Item 6.**Development Application: 2 Princes Highway, Alexandria - D/2023/806**

File No.: D/2023/806

Summary

Figure 25: Proposed General Arrangements Plan for the north of the site. The plan shows proposed tree plantings and new footpaths, including the through-site-link.

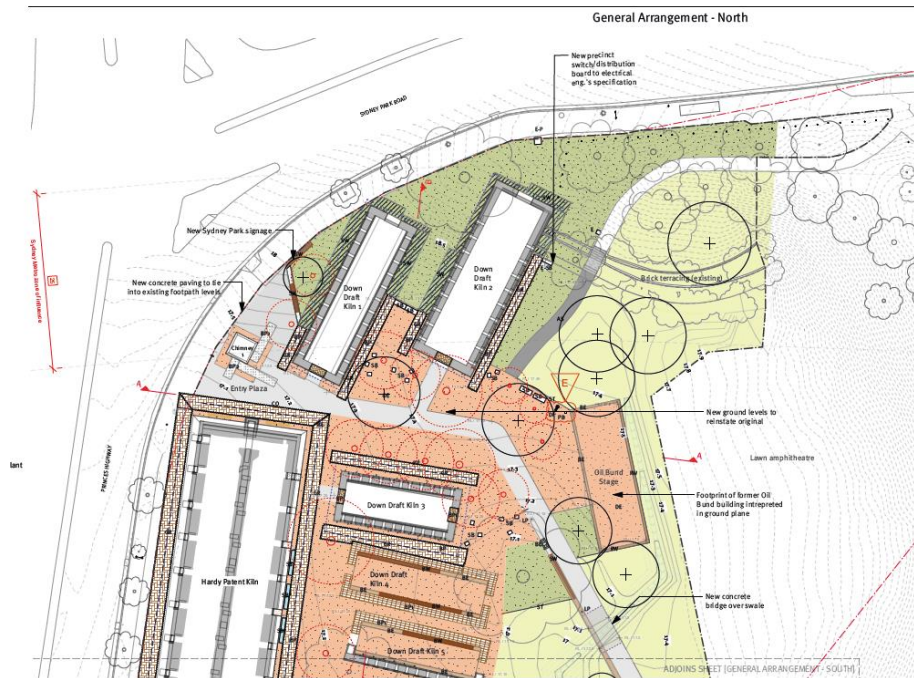
42. The proposal includes significant landscaping in conjunction with improved pedestrian footpaths, new plantings and improved open spaces. The submitted landscape plan has been assessed and is supported by the City's Landscape officer.
